Riley Purgatory Bluff Creek Watershed District Permit Application Review

Permit No: 2022-053

Project: Fox Ridge Addition—Proposed redevelopment of an existing single-family home parcel into three single-family residential lots with homes and an outlot in Chanhassen, MN. Stormwater management includes three subsurface stormwater management facilities to provide volume control, water quality, and rate control. A new outfall is also proposed to convey treated stormwater from the site into Lotus Lake.

Reviewer: Scott Sobiech P.E., and Annie Brunton, Barr Engineering

FOX RIDGE - ALTERNATIVE DISCHARGE OPTIONS
CHANHASSEN, MN

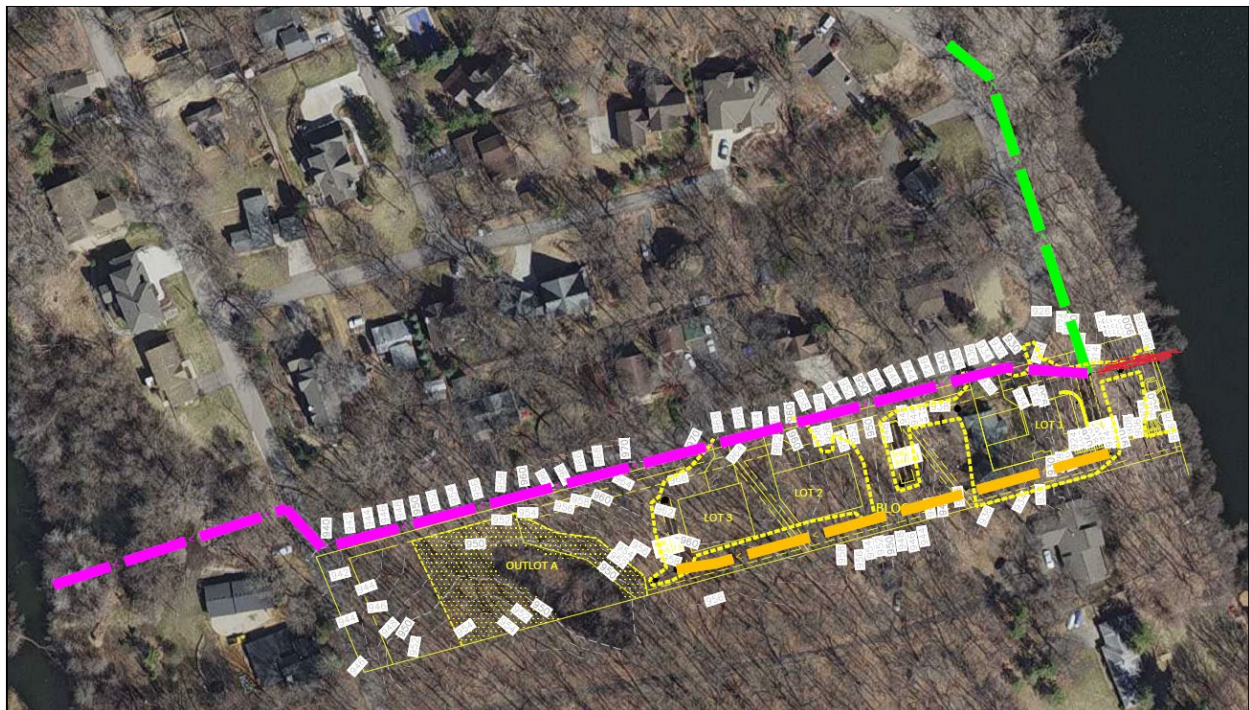
Rule G, Subsection 3.5a requires that the structure represent the minimal impact solution to a specific need. The applicant presented the four options shown in the below figure and summarized below.

- 1) **Option 1 (Green Routing):** There is an existing flared end section discharging drainage from Lotus Trail and the surrounding area into Lotus Lake approximately 310 feet north of the Lot 1 Stormwater BMP. Due to existing utilities within Lotus Trail, the storm sewer would likely need

to be installed on the lakeside of Lotus Trail. Installing the piping using traditional open cut methods would disturb a well vegetated steep slope riparian to Lotus Lake, including tree removal. The installation of storm sewer at depths initially in the approximate 20 feet range would require a significant wide trench even with trench boxes. This route is located on City of Chanhassen parkland and public right of way. Because the permit application does not have permission to work on city property, this option was dismissed.

- 3) **Option 3 (Magenta Routing):** There exists a stormsewer and flared end that outlets to the wetland complex to the west of the property slightly northeast of the intersection of the Fox Hill Drive and Carver Beach Road. Early in the process of this project the City of Chanhassen explored expanding ponds to the west in an attempt to consolidate stormwater on the Fox Ridge project. The topography indicates the high point in Fox Hill Drive is slightly above elevation 970, resulting in 62 feet of elevation change between the high point of Fox Hill Drive and the invert of the stormwater BMP for Lot 1 and the Lot 1 BMP is at a lower elevation than the existing wetland complex to the west, thus a stormwater pump station and forcemain would be needed for this option. Option 3 would also require disturbance of additional trees for the installation of a forcemain and stormsewer. A slight variation of Option 3 would be to only route runoff from Lots 2 and 3 to the west, which would not eliminate the need for the outfall to Lotus Lake. Because of the anticipated tree removals, stormwater pumping station requirements, this option was dismissed.

Because the outfall profile information shown on the drawing indicates the outfall will extend waterward of the OHWL and the associated riprap would be in contact with the lake bed, additional design revisions are needed to comply with subsections 3.5b and 3.5d.

- G1. The outfall location must be revised to allow for the installation of riprap and associated stilling basin consistent with the standard detail (plate 3107) included sheet 3. This will involve shifting the outfall west to minimize the encroachment and placement of riprap on the lake bed, thus achieving compliance with subsection 3.5b, 3.5d, and 3.7d.
- G2. Permit applicant must provide a draft maintenance declaration for the outfall structure for review and approval prior to recordation, in accordance with Rule G, Section 5.

FOX RIDGE
CHANHASSEN, MINNESOTA
PRELIMINARY PLAN
STORM SEWER PLAN AND PROFILES

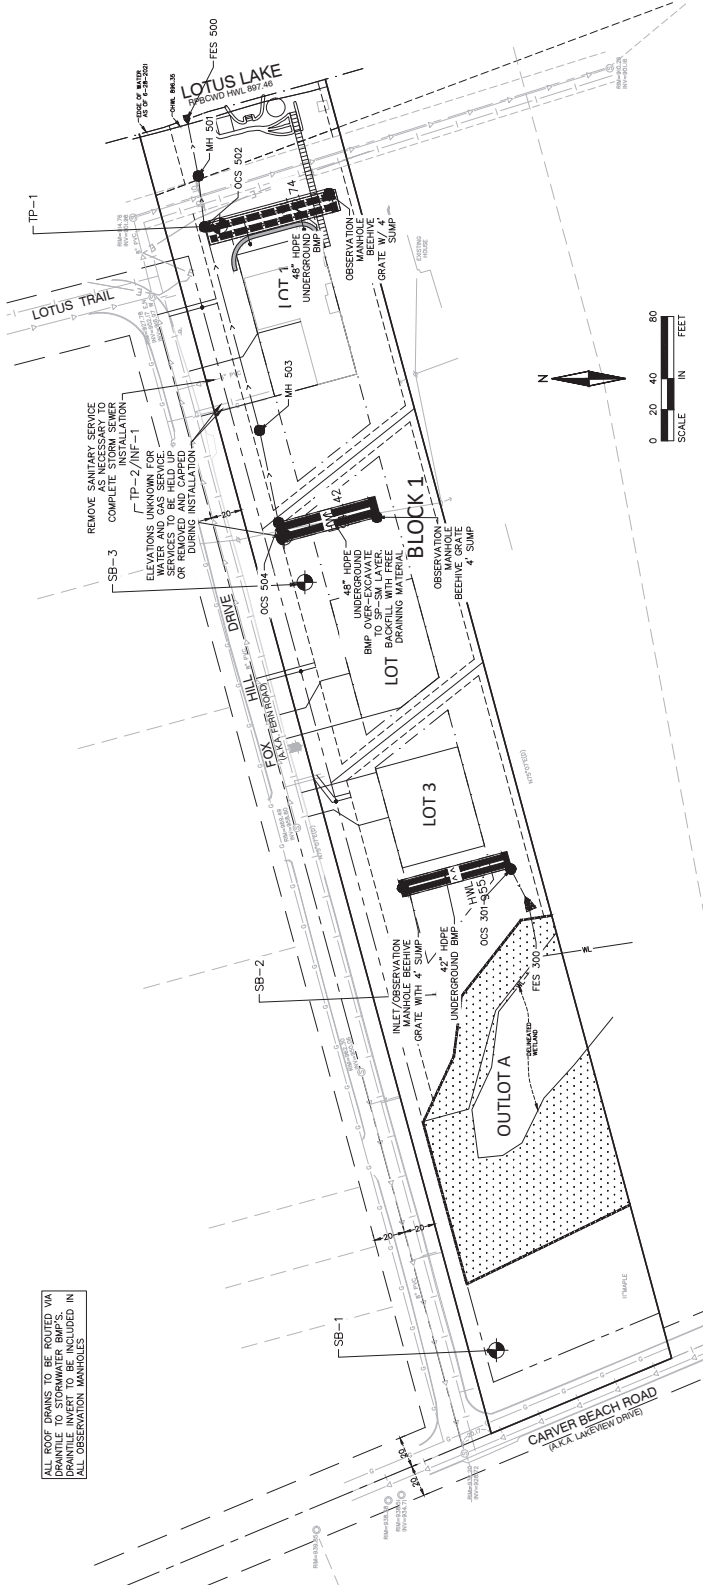
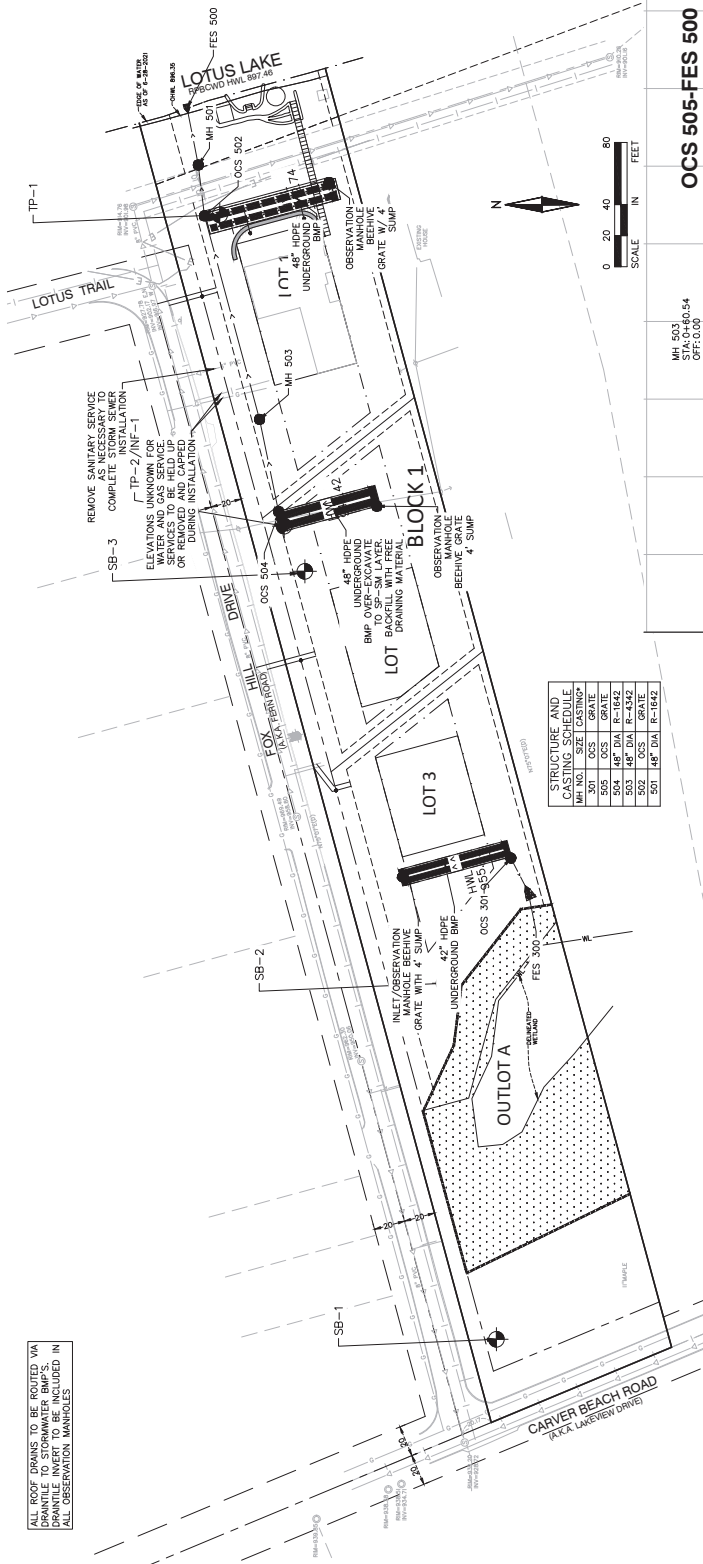
Plans submitted confirm that riprap is sized appropriately in relation to the erosion potential. Riprap is sized at 18 inches in diameter which is appropriately sized to withstand the designed discharge velocity of 7.9 feet per second, thus conforming to Rule F, Subsection 3.3b (i). Because the plans submitted indicate the proposed outfall construction along the bank of Lotus Lake will protrude waterward of the OHWL and has the potential to cover submerged vegetation slight alignment adjustments are needed to comply with Rule F, Subsection 3.3b (ii) and 3.3b (iv). The plans and details indicate that a transitional layer consisting of graded gravel, at least 6 inches deep with an appreciate geotextile fabric will be placed between the existing shoreline and rip rap, thus conforming to Rule F, Subsection 3.3b (iii). As shown in the riprap detail in the plans, the riprap is proposed to extend to the area around the top of the pipe below the Lotus Lake 100-year floodplain elevation of 897.46 NGVD29, consistent with Rule F, Subsection 3.3b (v). The riprap design reflects energy dissipation and stabilization necessary to minimize erosion at the streambank and is not placed for cosmetic purposes per Rule F, Subsection 3.3b (vi).

3. Receipt of revised plans realigning the outfall location to allow for the installation of riprap and associated stilling basin consistent with the standard detail (plate 3107) included sheet 3. This will involve shifting the outfall west to minimize the encroachment and placement of riprap on the lake bed, thus achieving compliance with subsection 3.5b, 3.5d, and 3.7d.
